January 28, 2025  
File No. 03.0035410.00

Re: Response to January 2025 Redesign  
Peer Review of Stormwater Mound Evaluation  
Proposed Thorndike Place Residential Development  
Arlington, Massachusetts

THORNDIKE PLACE			
ARLINGTON		MASSACHUSETTS	
SUBSURFACE EXPLORATION PLAN			
FOR			
DINOSAUR CAPITAL PARTNERS LLC			
BY			
McPHAIL ASSOCIATES, LLC			
Date: DECEMBER 2024	Dwn: I.J.M.	Chkd: S.S.S.	Scale: 1" = 50'
Project No: 7679

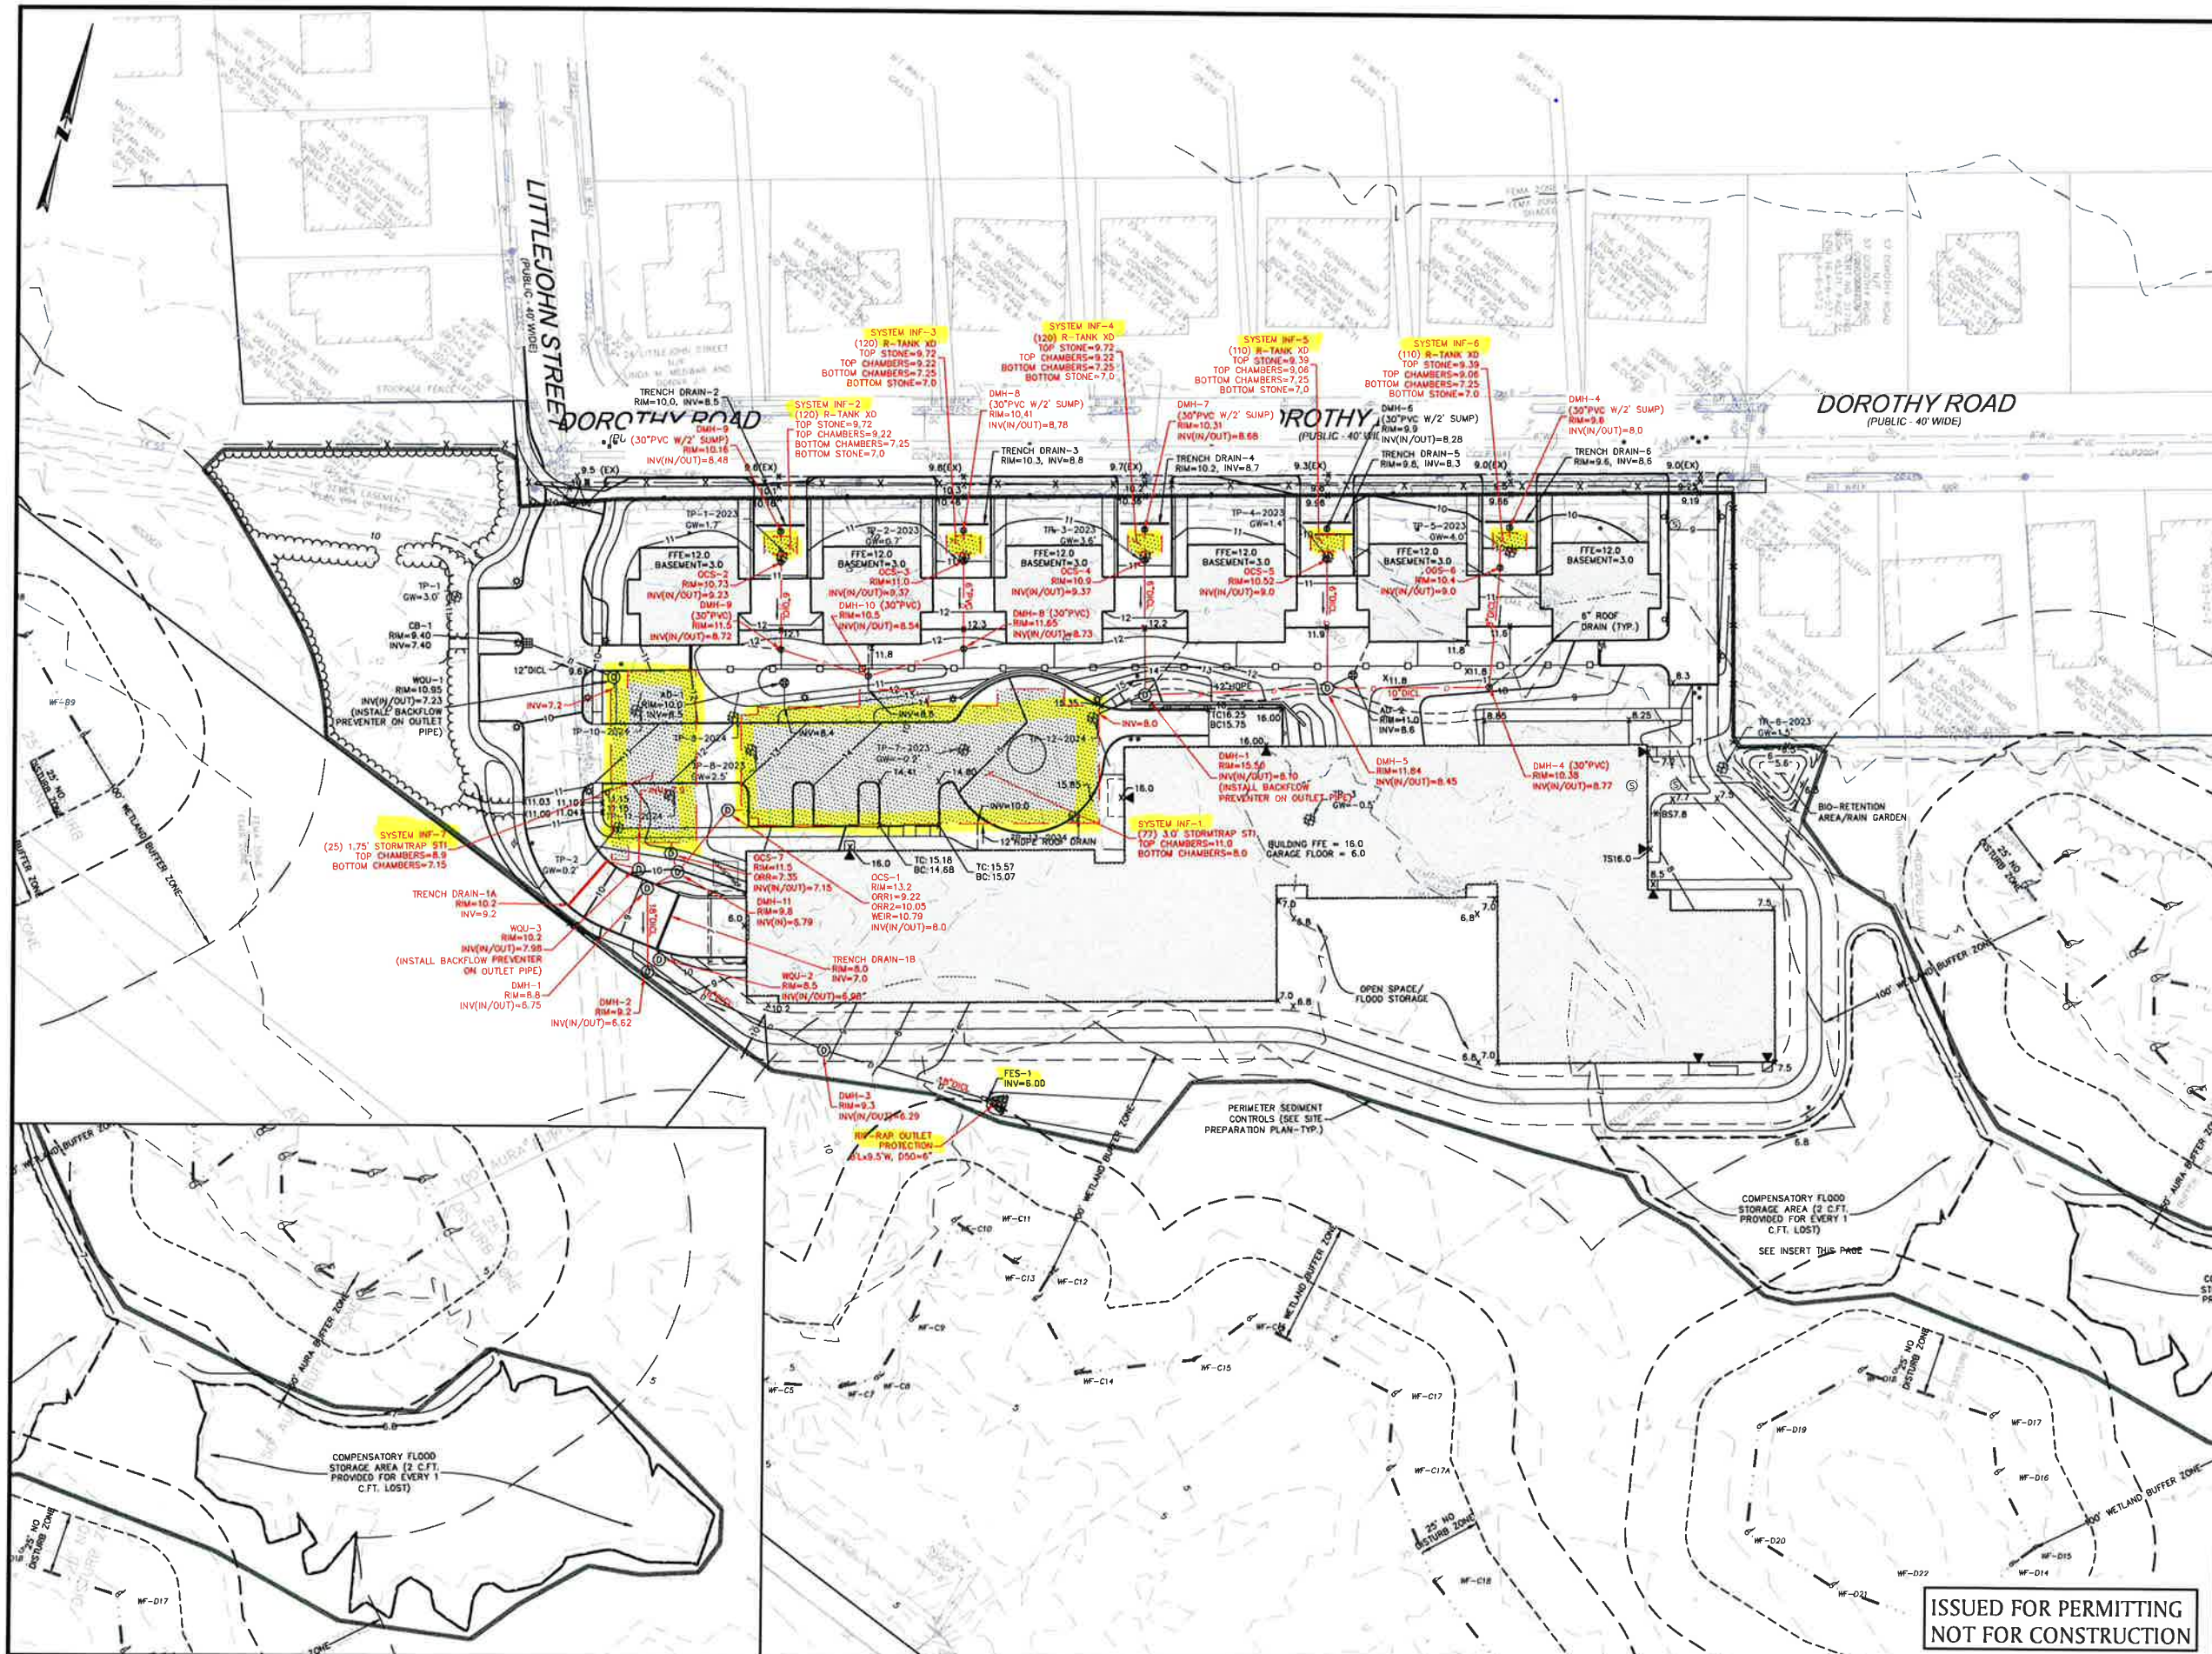
Two new test borings (MA-1 and MA-2) were performed in the area of proposed Infiltration Systems 1 and 7 on November 20, 2024. The test boring logs and a figure depicting the location of the test borings is provided in **Appendix B**. These borings were performed to better understand the depth to a restrictive layer to more accurately determine the initial saturated thickness to be used in the groundwater mounding analysis. The previous groundwater analysis was performed using a saturated thickness of 5 feet, which represented the maximum depth of the test pits below the ESHWT. The two new borings showed a marine clay layer with a highest elevation between -12.1 and -17.4 feet. Based on that data, BSC used an aquifer saturated thickness in their mounding analysis of 16 feet representing the depth between the ESHWT (4.0) and the shallower marine clay layer (-12.1).

GZA's review of the new test boring logs (MA-1 to MA-2) provided in Appendix B indicate that below the upper fill strata, alluvium deposits of stratified sand deposits with trace amounts of silt, and silty sand deposits were encountered in both borings to a depth of 20 to 28 feet below grade (elevation -12 to -17 feet), at which point a low permeability clay layer was encountered. The deeper clay strata was encountered at boring MA-1 which was performed in the area of proposed Infiltration System 7. It is GZA's opinion that this new subsurface information indicates that using an aquifer saturated thickness of 16 feet in the groundwater mound analysis, instead of the previous 5-foot thickness, is a reasonable assumption.

However, we note that a fibrous peat (organic deposit) was encountered in boring MA-2 between a depth of 5.5 and 8 feet (elevation 2.4 to -0.1 feet). Boring MA-2 was performed on the eastern side of Infiltration System 1. It is GZA's opinion that the organic deposit encountered beneath the eastern portion of Infiltration System 1 is a low permeability deposit that may adversely impact the functionality of Infiltration System 1. GZA recommends that the organic deposit be removed from the area of Infiltration System 1 and then be replaced with clean sand backfill up to the bottom of Infiltration System 1.

1. If the nearby building's groundwater underdrain system is installed beside Infiltration System 1 and if the organic deposit (peat layer) in the eastern portion of the Infiltration System 1 is removed and replaced with clean sand up to the bottom of the Infiltration System 1, then we do not anticipate that the adjacent mounding due to Infiltration System 1 will adversely impact the mound conditions at Infiltration System 7.
